RE: PATRONSKI SITE PLAN - 4096 ONNALINDA DRIVE (LOT 2 WESTBROOK SUBDIVISION)

SITE PLAN REVIEW

MRB PROJECT No.: 0300.12001.000 Phase 126

# TYPICAL WATER SERVICE

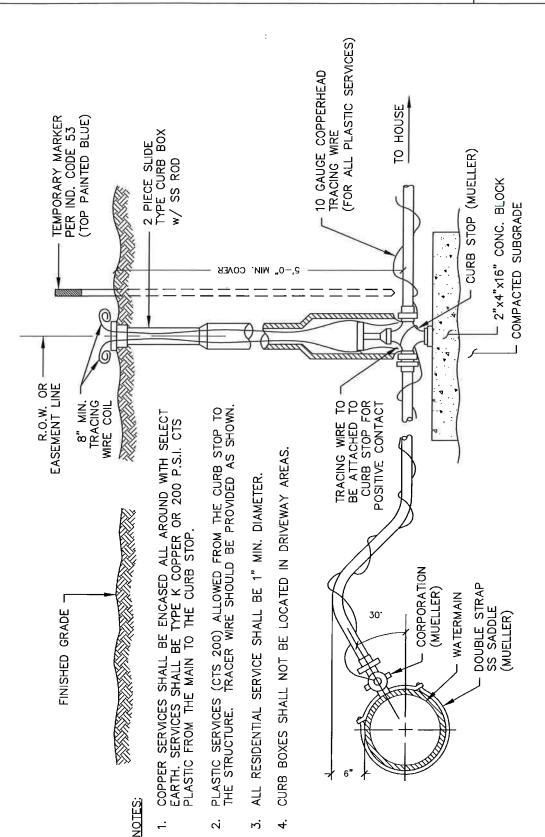
- 13. The MRB logo on the detail plans should be removed.
- 14. Please remove the water service detail and use the attached updated version.
